**WHITE LAKE TOWNSHIP
INTER-OFFICE MEMORANDUM
COMMUNITY DEVELOPMENT DEPARTMENT**

**SUBJECT: Culver's
Preliminary site plan approval**
Property described as parcel number 12-20-276-035, located on the north side of Highland Road (M-59) and west of Bogie Lake Road, with a project area on the parcel consisting of approximately 1.69 acres, currently zoned (PB) Planned Business District.

RE: Culver's- Preliminary Site Plan Review – 2nd Review

RE: Culver's
Preliminary Site Plan – Review #2

COVER SHEET

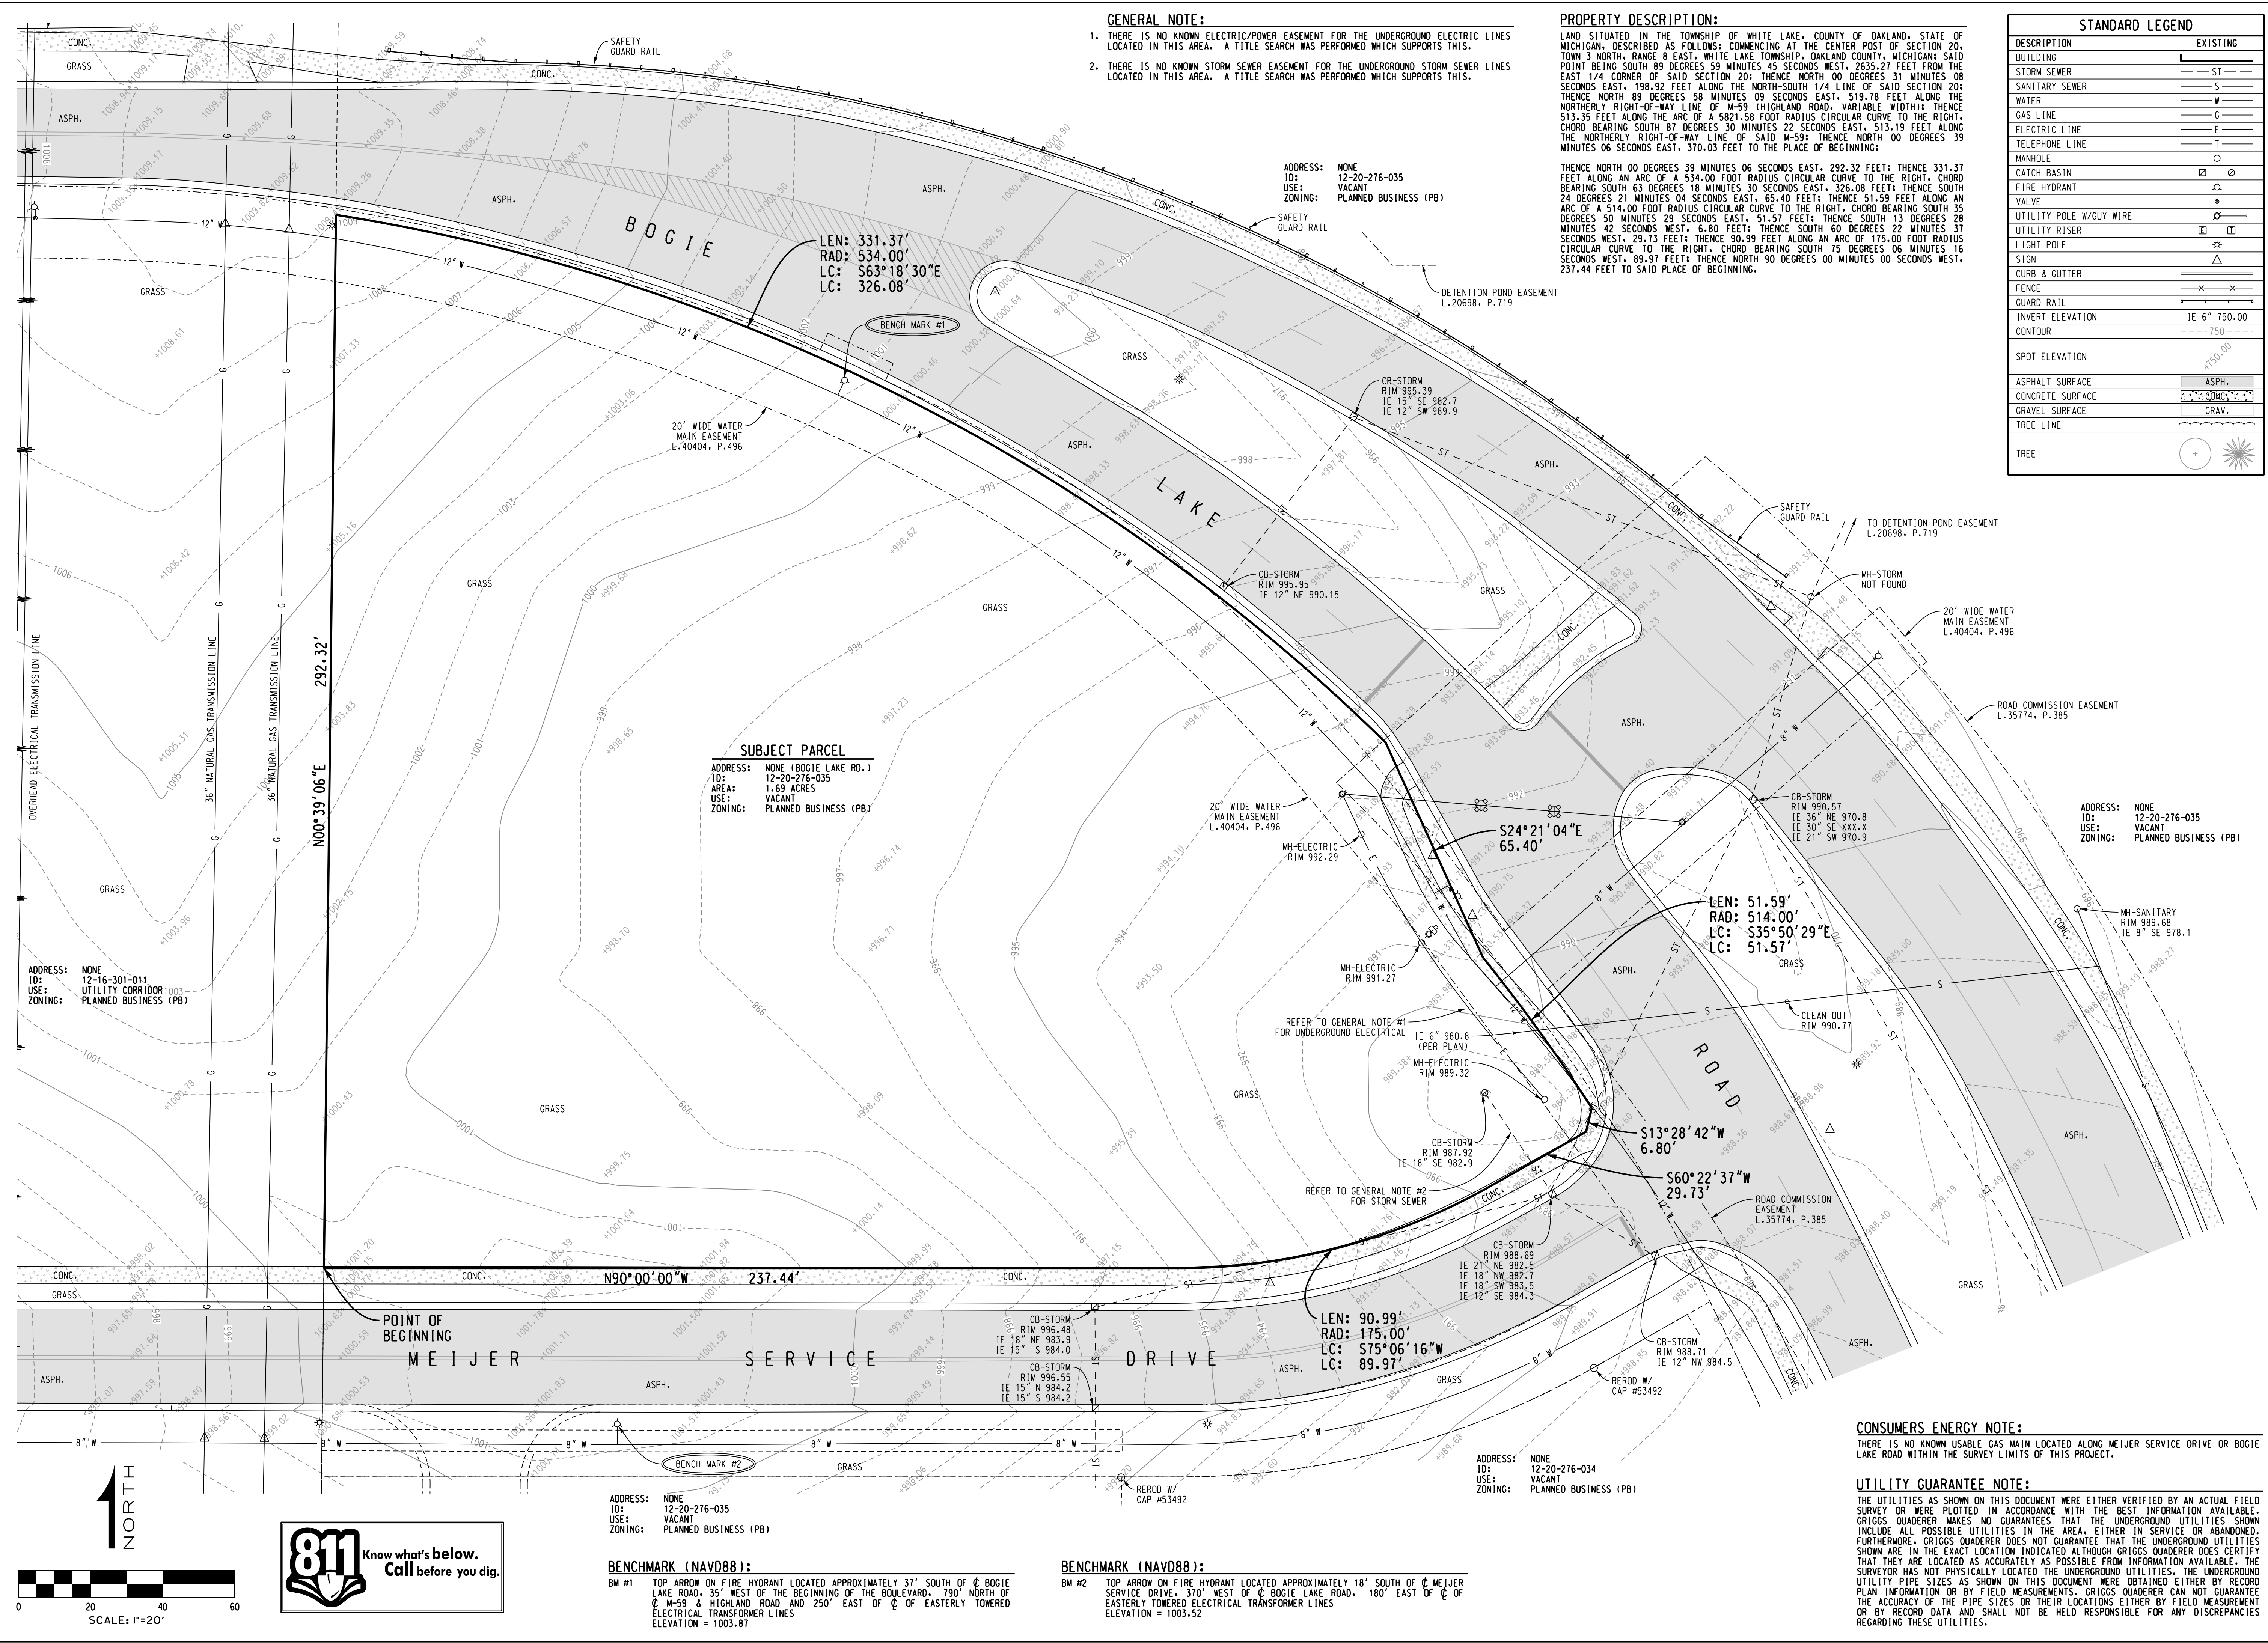
- a) *Cover sheet C000- Correct spelling of Bogie Lake Road. Currently spelled "Boagie."* **Comment addressed. Spelling has been corrected.**

PHASE: P. SPA
 JOB NO.: 230601
 10th Anniversary 2004-2023
C200

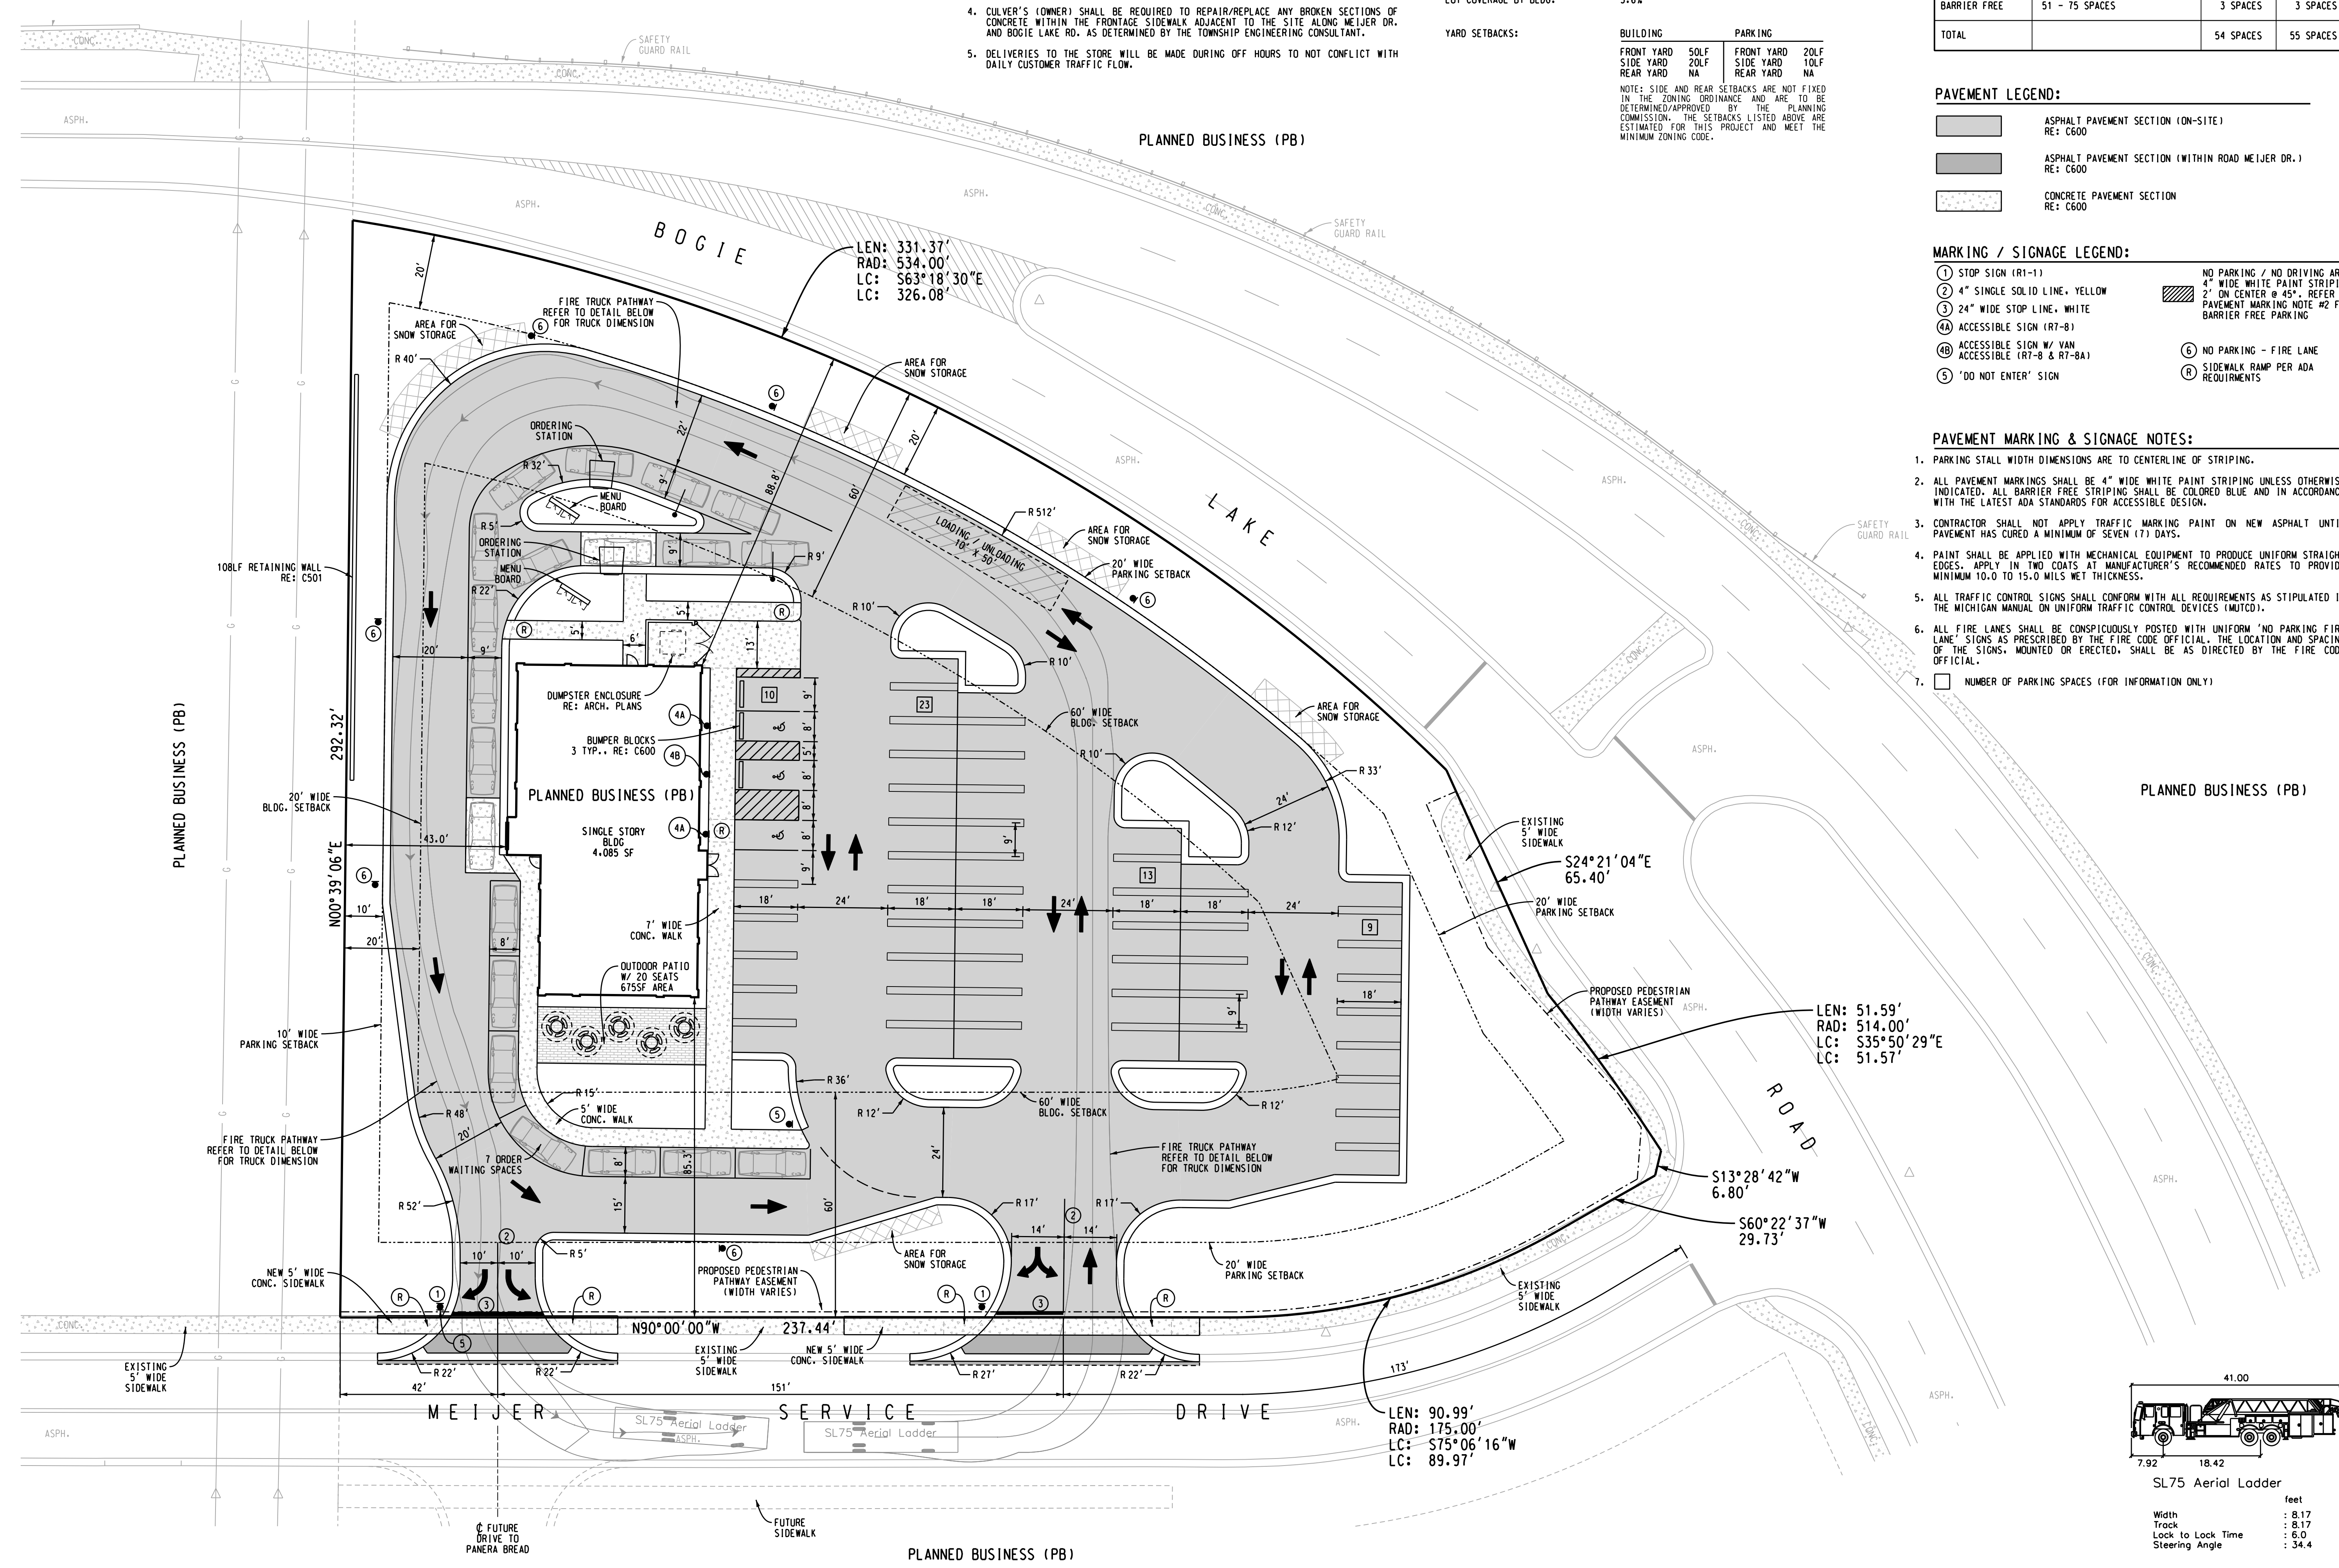
- j) *Sheet C200- It is not clear why bumper blocks are being proposed where the ADA parking + one regular parking space abut the proposed sidewalk. Although the sidewalk abutting the spaces with bumper blocks will not be raised, the sidewalk to the south at a point would still need a sloped sidewalk/ramp up to allow ADA customers access to the restaurant door since the southern portion of this sidewalk does indicate a 6" raised sidewalk. Please review. **Comment addressed and remains as a notation. The design engineer notes the sidewalk adjacent to the bumper blocks shall be flush with the pavement area, with a ramp up to the main entrance proposed. Details for ramp up to main entrance along with proposed grades (meeting ADA requirements) shall be provided on the FSP/FEP.***

- k) *Sheet C200-The 15' wide one way driveway on the south side of the restaurant does not meet the Township minimum 20' width requirement for one way drives. We defer to the Township Planning*
-

- l) *Sheet C200- Clarify the sidewalk easement intent for the existing sidewalks along the Meijer Service Drive and Bogie Lake Road. Is the easement proposed or existing? In addition, we defer to the Township Planning Department as to whether the existing sidewalk along Bogie Lake Road shall be required to be extended to the northwest along the Bogie Lake Road frontage per Township Zoning Ordinance requirements. Comment addressed and remains as a notation. A portion of the existing sidewalk is within the Culver's property and the design engineer has stated the intent to grant pedestrian access along the existing sidewalk to allow for continued use. We continue to note the requirement for a sidewalk easement for the portion of sidewalk on the Culver's property that is outside the Bogie Lake Road ROW. We continue to defer to the Township as to whether the existing sidewalk along Bogie Lake Road shall be required to be extended to the northwest along the Bogie Lake Road frontage.*

Two proposed driveways to the Meijer private drive would provide access to the site. The Zoning Ordinance states the number of driveways permitted for a site shall be the minimum number necessary to provide safe and efficient access for regular traffic and emergency vehicles. **The westerly driveway should be eliminated. Revise accordingly. (Comment remains as a notation. The Applicant is requesting a secondary driveway be allowed on the west side of the site. Staff defers to the Planning Commission on this request. It should be noted the Applicant is also requesting a waiver to reduce the required drive aisle width for a one-way drive along the south side of the building from 20 feet to 15 feet). If not removed, the westerly driveway is deficient in width (one-way undivided driveways must have a width of 20 feet) and shall be widened accordingly (dimension this driveway width on Sheet C200). (Comment addressed. The drive width has been labeled with dimensions on Sheet C200).**

An outdoor patio with 20 seats (five tables) is proposed on the south side of the building. **Label the size (square footage) of the patio on Sheet C200. (Comment addressed. A note has been added to Sheet C200 indicating the patio is 675 square feet in size).**

Department regarding this item. Comment addressed and remains as a notation. Per the design engineer, Culver's shall be requesting a variance for the reduced drive width. We continue to defer to the Township regarding this item.
